Loop Road Proposal and Analysis

Analysis of loop road option for access to Hornsby Aquatic Centre

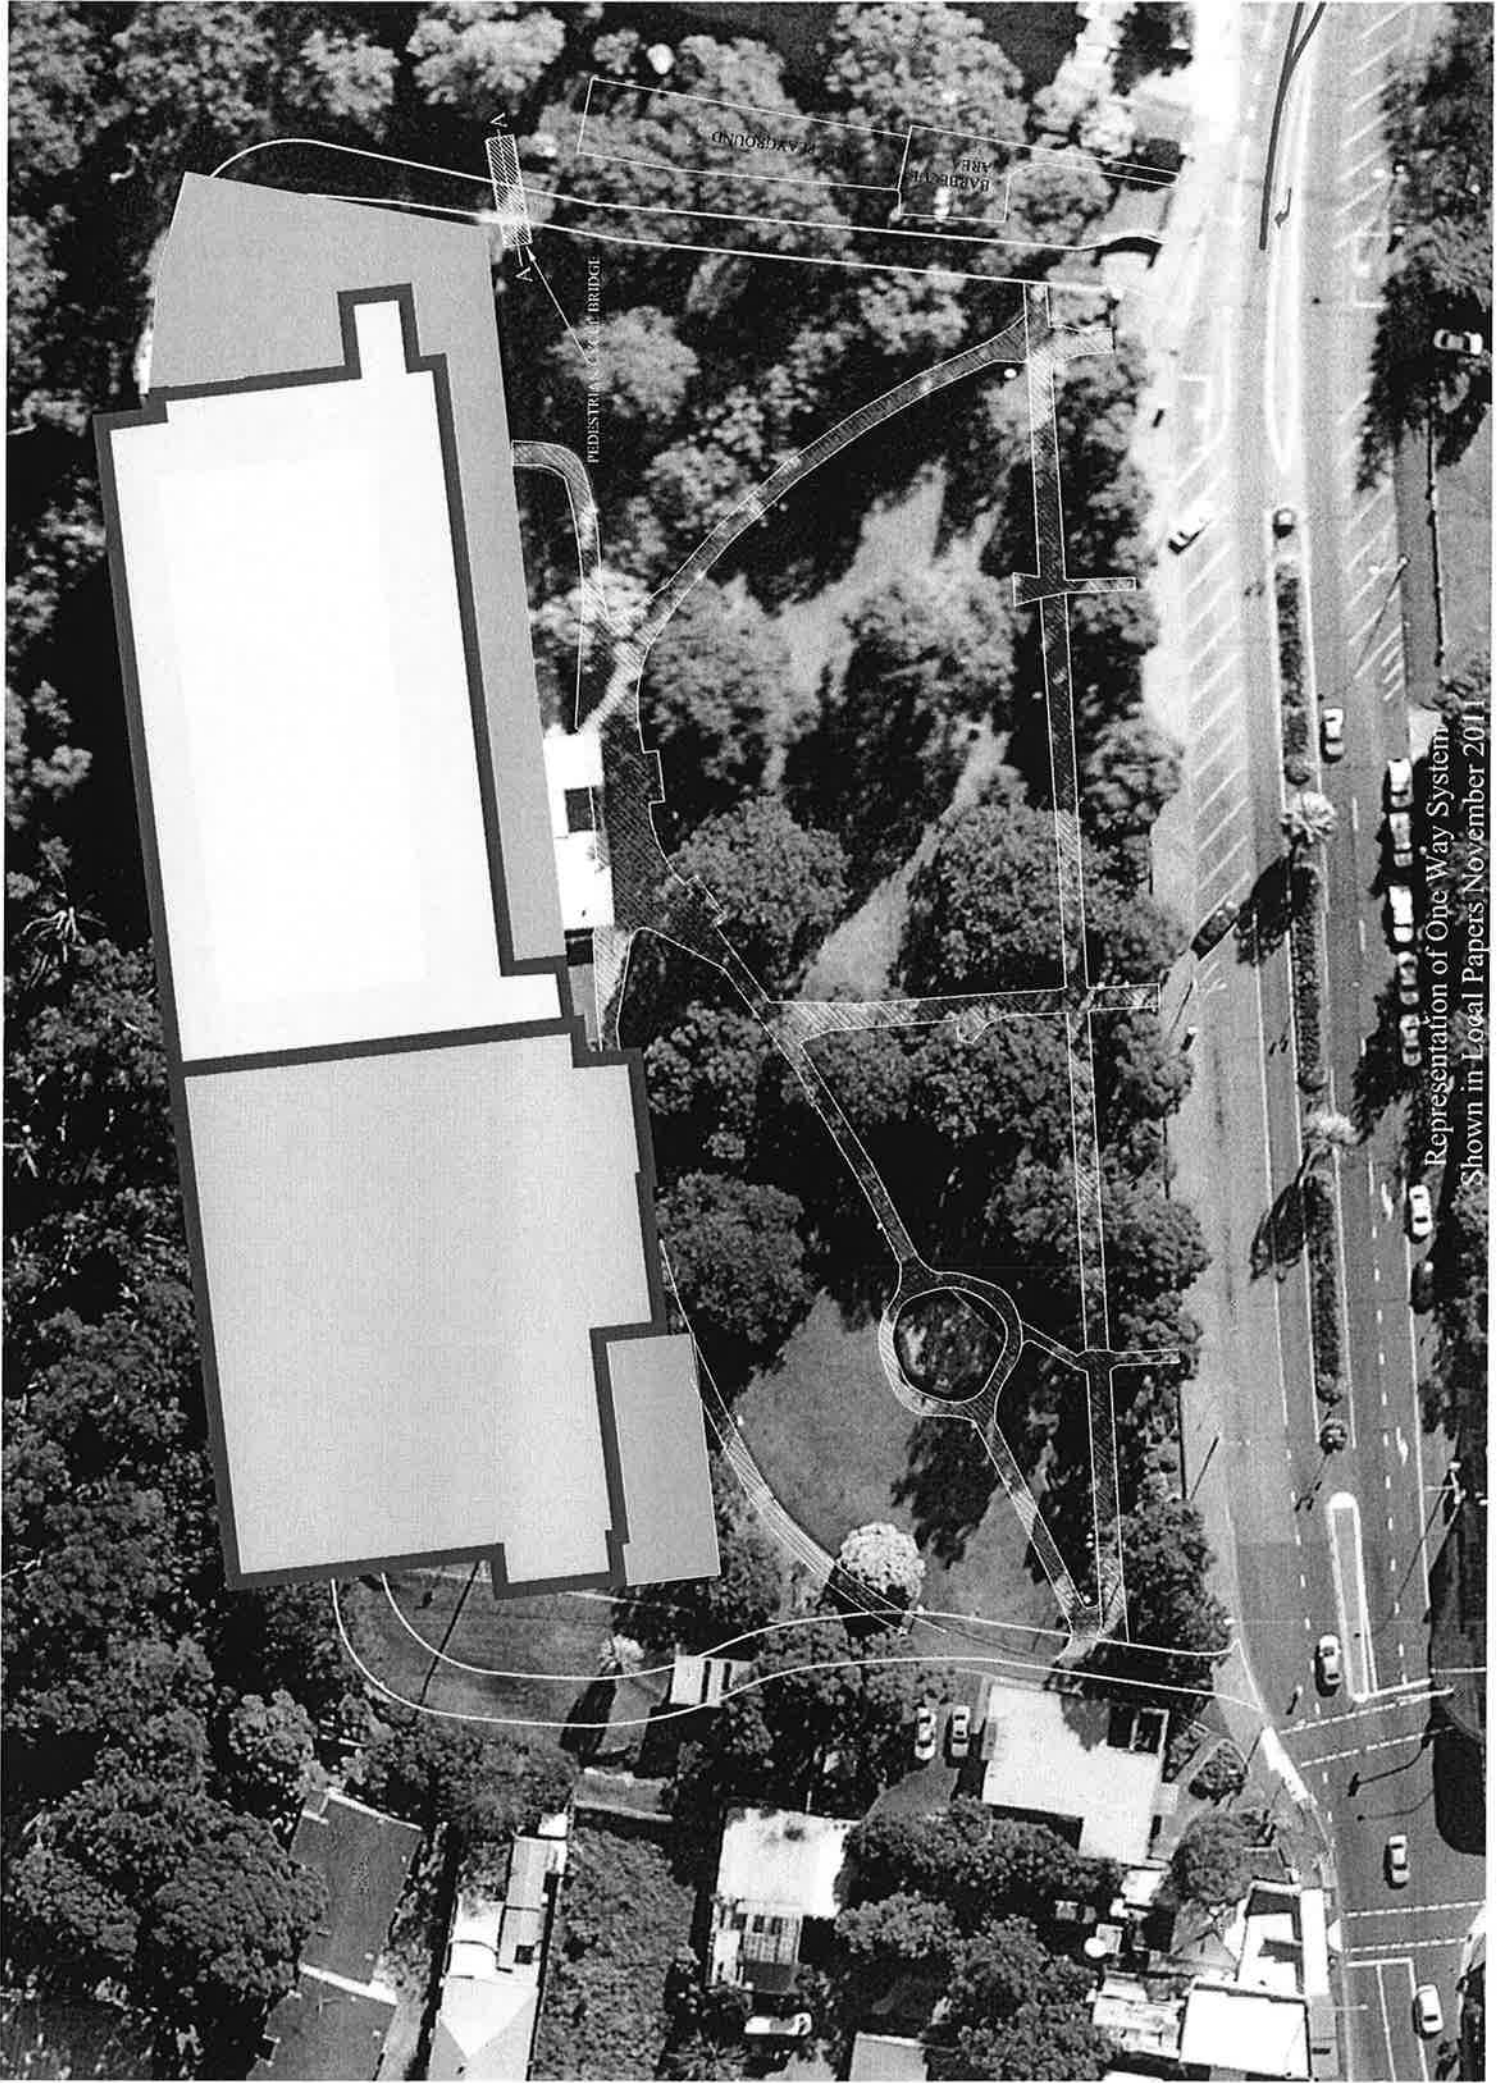
1. Vehicles can enter carpark from all directions. HRVs can only access site by a right turn unless one of the sandstone entry walls is removed or relocated to allow for the truck turning path.
2. Poor sight distance turning right with central garden light posts and palm trees in centre median restricting sight of oncoming vehicles. This would require modification and a heritage assessment. A dedicated right turn bay on the highway would be required in order to prevent blocking of through movements when vehicles are waiting to

turn right into the site. Right turn bay will be used for TAFE access as well as HAC access - considerable risk of "rear enders" especially as HAC users will be less familiar with the area and not expecting vehicles to stop prematurely for TAFE driveway.

3. Due to traffic conditions, vehicles turning right into the site would experience delays as they have to give way to northbound traffic on the Pacific Highway. Should more than 3 vehicles queue waiting to turn right, the southbound through lane will become blocked, causing traffic delays.

4. Does not take into account the full extent of the new Hornsby Aquatic Centre. The Development Application plans (DA05) show an area labelled "*new grass area (future aquatic features)*" at a level of RL182.50, 1.2 metres higher than the pool concourse. This is also shown on section d on plan DA08. This area is for future expansion of the facility to allow for such things as a larger water slide or a wave rider. This area for future expansion was requested by members of the Deliberative Forums held in April this year. In attachment 3 of the abovementioned Council report the section for Option 3 shows that 4 metres of excavation is required at this point. This was required to allow vehicles to enter the carpark and also to provide a pedestrian and bicycle bridge over the roadway for access to the northern section of the park and Old Mans Valley.

5. The proposed carpark has to be lowered by 1.6 metres to allow HRV's which includes garbage trucks under the pool. Council determined a car park height of 3.5 metres which was based on the height of the largest piece of plant that will need replacement during the life of the pool with the garbage truck and other HRV's provided with a turning area on the driveway clear of the carpark. Further the carpark under the deep end of the 50m pool (1.8m) has a clearance of 2.8 metres which is suitable for cars. The cost for lowering the carpark has been estimated in excess of \$1.4M.

6. No loss of on street parking, however, loss of overflow carpark to north of existing pool due to lower road levels.
7. Grades for a HRV cannot be achieved without major impact on the park. Road entry level at the highway is approximately 2.3 metres higher than southern end of park. An access road would start to go below existing surface level approximately 15 metres into park and approximately 4m below existing level approximately 65 metres into park, requiring safety fences and significant retaining walls.

8. Entrance road located away from residential area, reducing the noise impact on Dural Street properties adjoining Hornsby Park.

9. Difficult access for construction traffic and impact on significant trees which would potentially impact on the heritage of the park. As a minimum, some heritage trees will require branch removal to allow for clearance.

10. A two way roadway needs to be constructed during demolition and construction of the new HAC.
11. On Crown Land for which Council is the Reserve Trust, therefore this option does not require property acquisition.

12. Significant impact on the heritage values of Hornsby Park with existing entry wall and gardens requiring partial demolition, two (2) mature Turpentine (heritage trees) requiring removal and potential impact to the root system of many others. Impact on existing sandstone retaining walls and isolation of playground and BBQ area. Play area may need to be relocated elsewhere in park. Would be difficult to optimise the use of this area of the park. Access to heritage stairs to Old Man Valley compromised, and would require a bridge from the park over the proposed access road. Significant visual impact of road through park requiring fencing.

13. Other issues include possible impact on utility services.

14. Not possible to connect exit road to Coronation Street traffic lights as the signal cycle time allowed for an expanded intersection would significantly increase delays through the intersection. Would not receive RTA approval.

15. Exit therefore only to the north.
16. Exit alignment does not conform with AS2890.1 Parking Facilities Part 1 – Off Street Car Parking which requires the driveway to be set back 6 metres from end of the central median. If the location is adjusted to conform it will result in poor alignment at driveway crossing and encroach on open space within the park.

17. Without traffic signals, vehicles would exit via a driveway. Vehicles waiting to exit the driveway will block the footpath along the Pacific Highway.

18. Patrons wanting to head south would either make U turn at northern end of median or travel north on Pacific Highway and turn right at Bridge Road. This is a poor design that results in poor traffic circulation.

19. Conflict with median separation provided for police vehicles on the Pacific Highway opposite this entry/exit.
20. Grades and turning path for HRV achievable.

21. Minimises available space for proposed site compound area in southern section of Hornsby Park. Other land not available in close proximity
22. Significant impact on heritage values of Hornsby Park with greater intrusion into the park, removal of curved pathway and alienation of CWA building.

23. CWA amenity compromised with close proximity of access road, and the demolition of the main public toilets in the park, however, the accessible toilet near the Pacific Highway is to remain, and if not considered sufficient, additional toilet facilities will be constructed at the northern end of Hornsby Park

24. Total Cost – Approximately \$3M, which is \$2.2M more than option 1 shown in Council Report WK59/11 on which the DA is based upon.

Long and Cross sections of northern Access Road

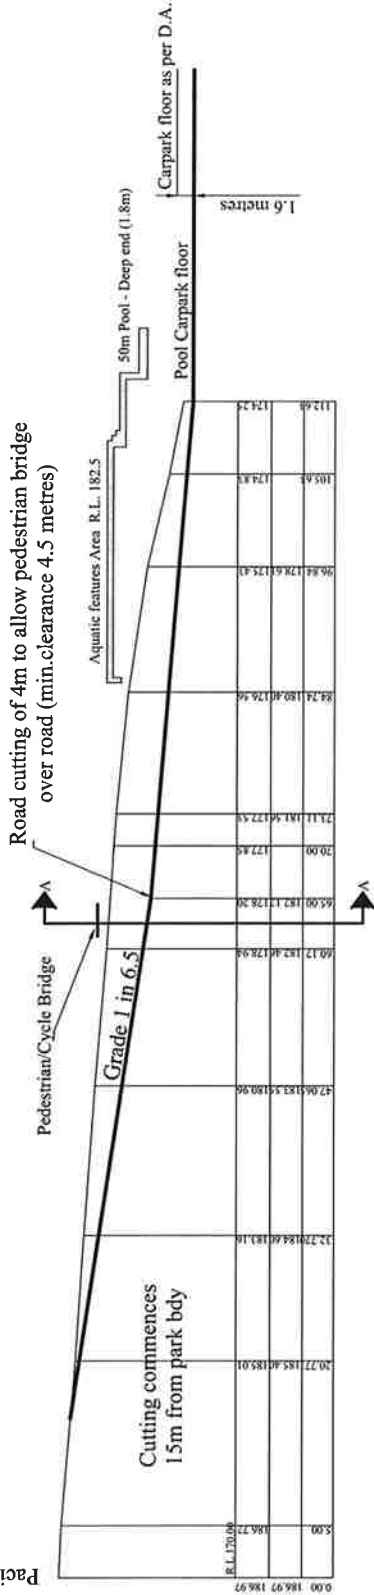
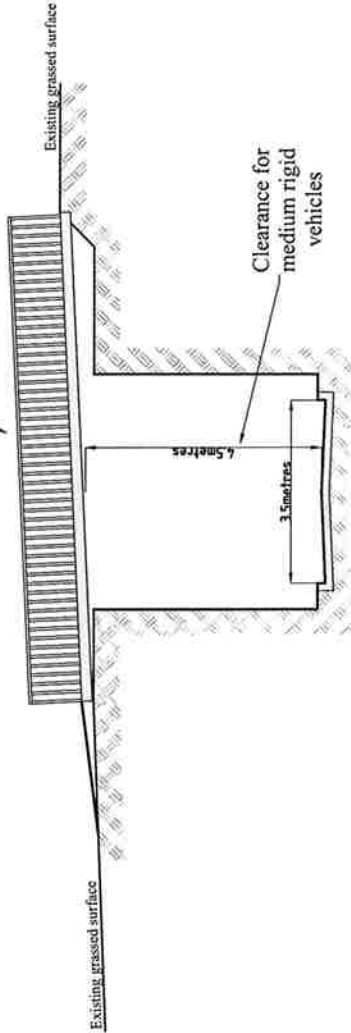
Road @ maximum grade of 1:6.5 to meet Australian Standards.

One way entrance at Northern end of Hornsby Park

Pedestrian /Cyclist bridge to northern end of Hornsby park
